DEVELOPMENT APPLICATION NO: DA19/0875

URBIS RESPONSE TO PENRITH CITY COUNCIL REQUEST FOR ADDITIONAL INFORMATION – 27TH APRIL 2020

Response to RFI Relating to Visual Impacts

NEPEAN GARDENS, WALLACIA, NSW

DATE: 22.05.2020
JOB NO: P0014166
DWG NO: VP_C3
REV: -

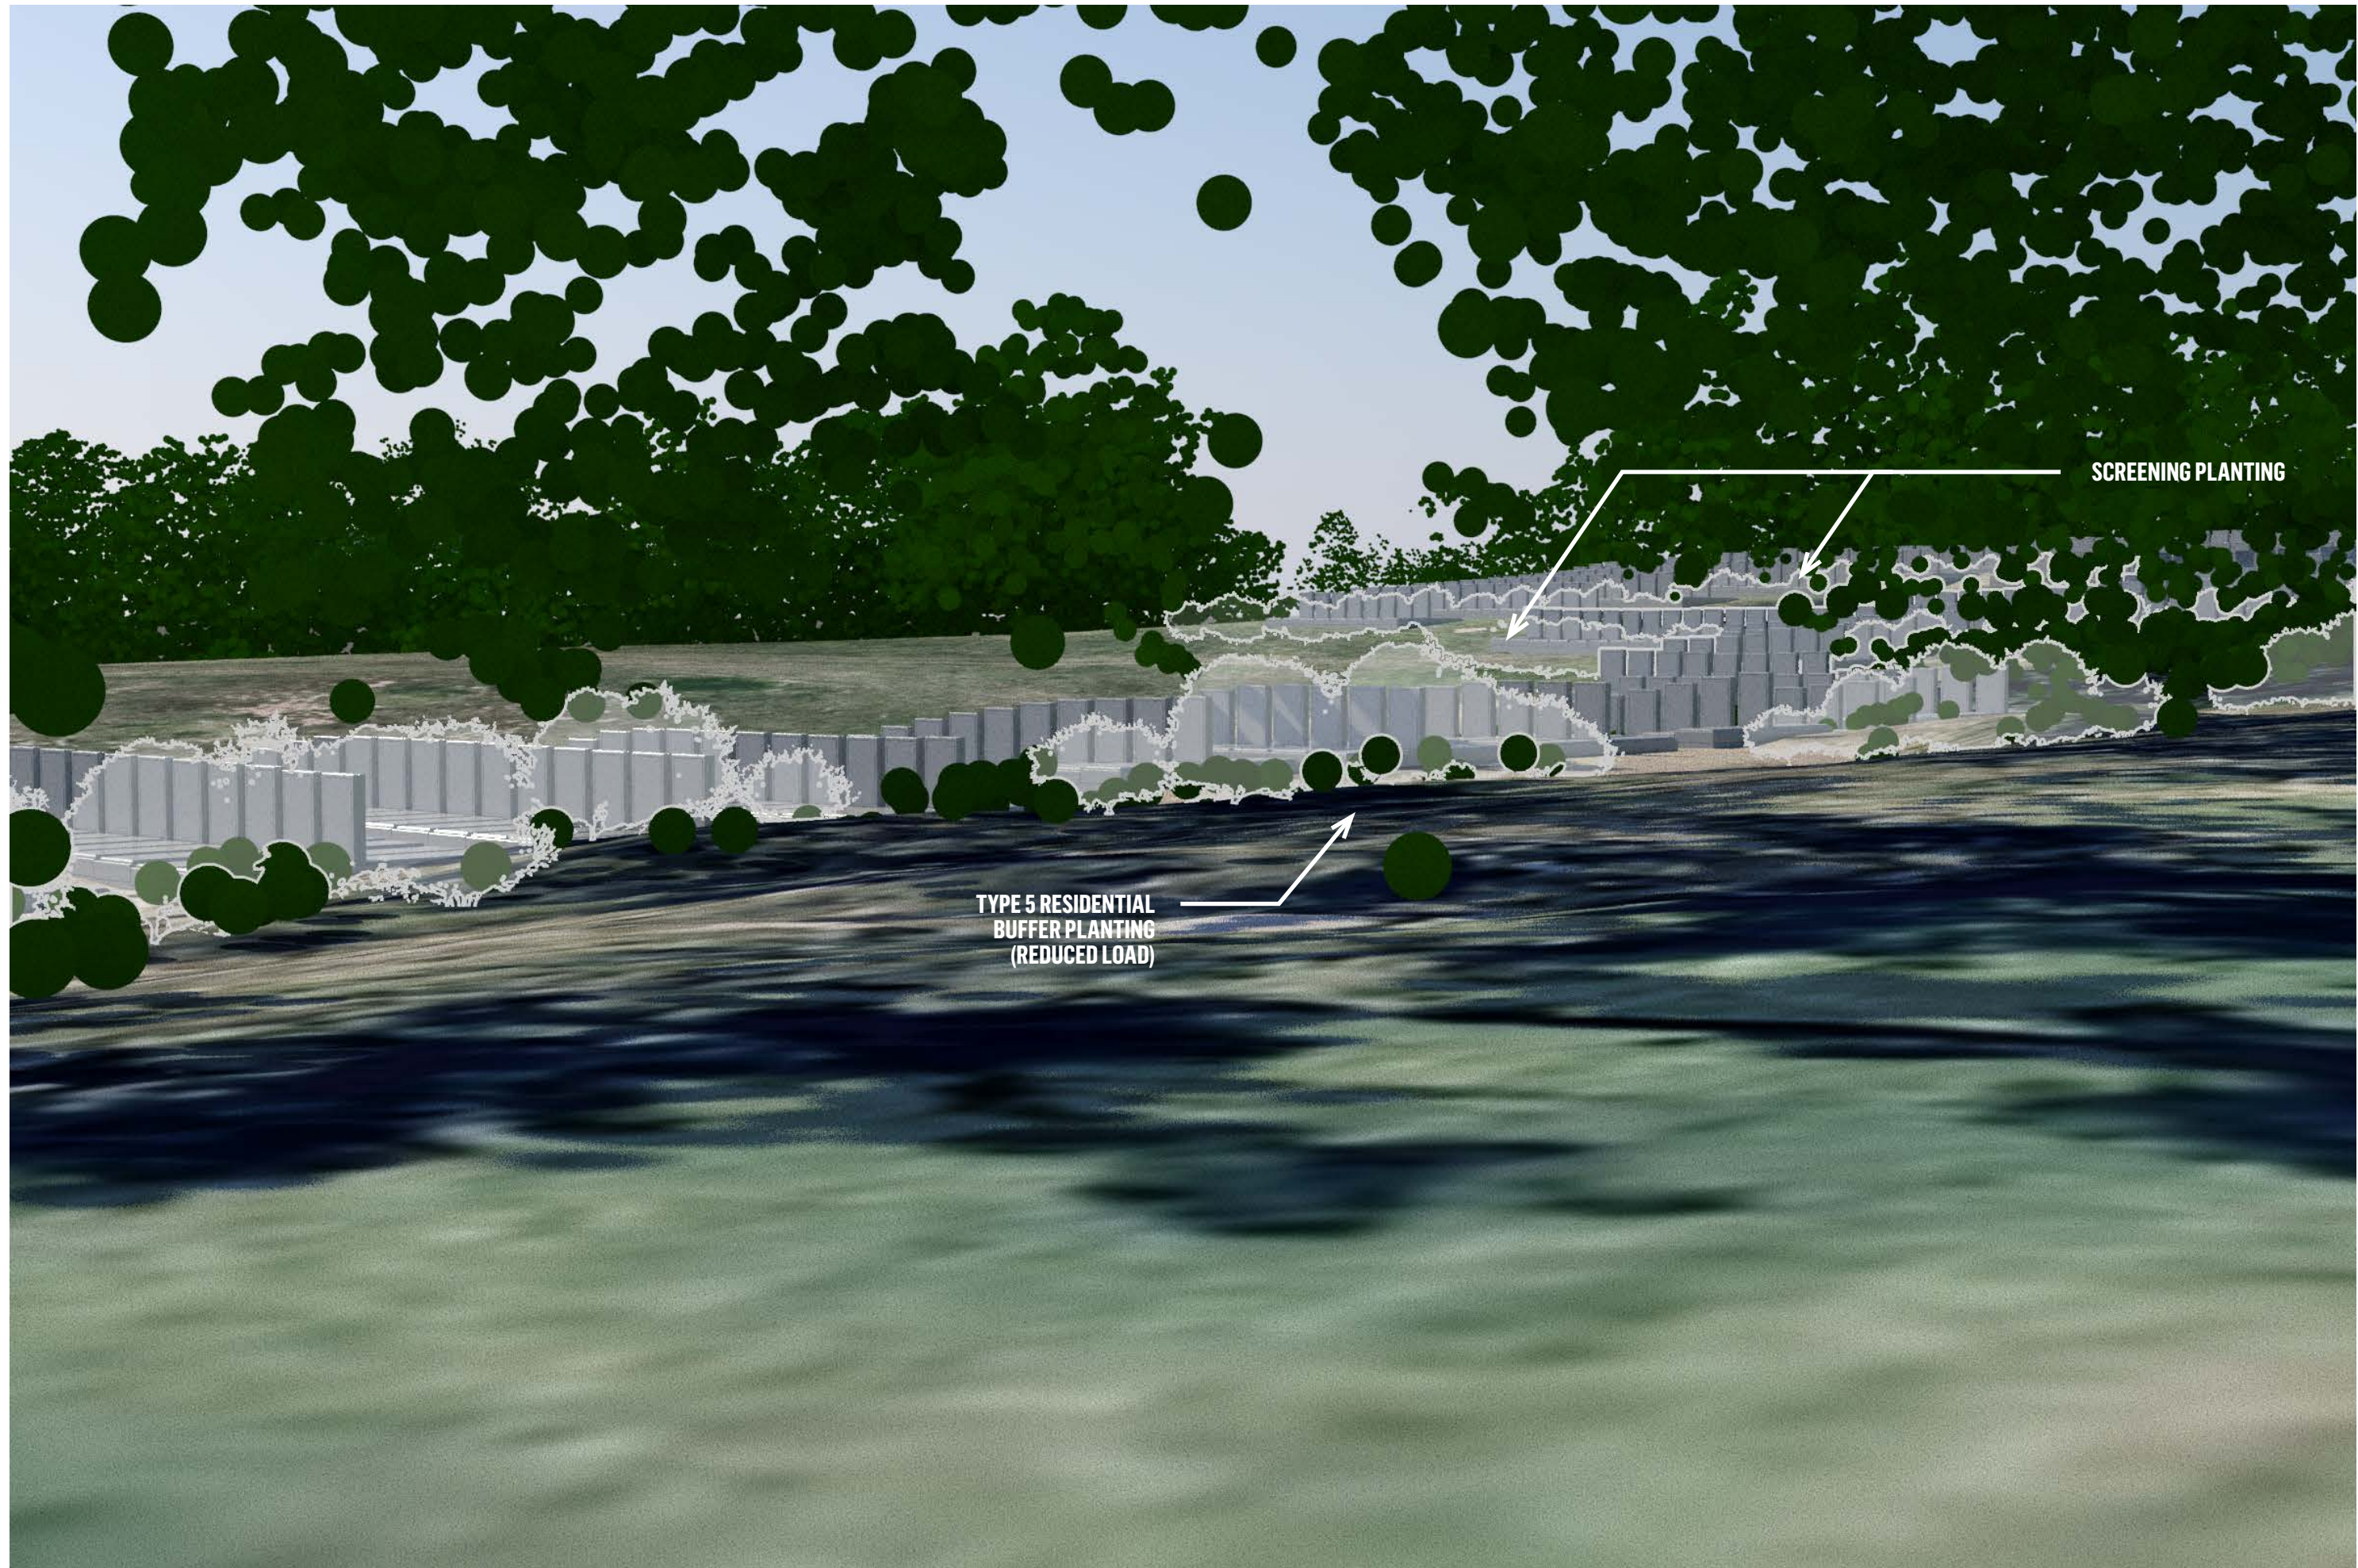
(h) The proposal for Type 3 - 1.5m high memorial head stones is likely to impact poorly on views from neighboring rural residential properties. A response is requested as to why memorial headstones should not be limited in height to 600-800mm, so as to be less visible. The impact of the proposal for Type 4 - Full monumental installations needs to be assessed and in this regard, further detail is to be provided as to the allowable dimensions and locations for this typology. A view analysis or montage may be required.

- VP A – 0.19° vs 0.52°
- VP B – 0.53° vs 1.14°
- VP C – 0.76° vs 1.23°

In all views, the buffer landscaping is highly effective at ameliorating views from surrounding areas. Given the headstones are only 1.5 m in height, buffer planting proximate to viewing location is highly effective in screening views within a relatively short period of time. Post planting, the landscape will gradually reduce views of the monuments. The computer simulations demonstrate that after 5 years, the landscaping will be of a height to effectively screen views to the tops of the monuments.
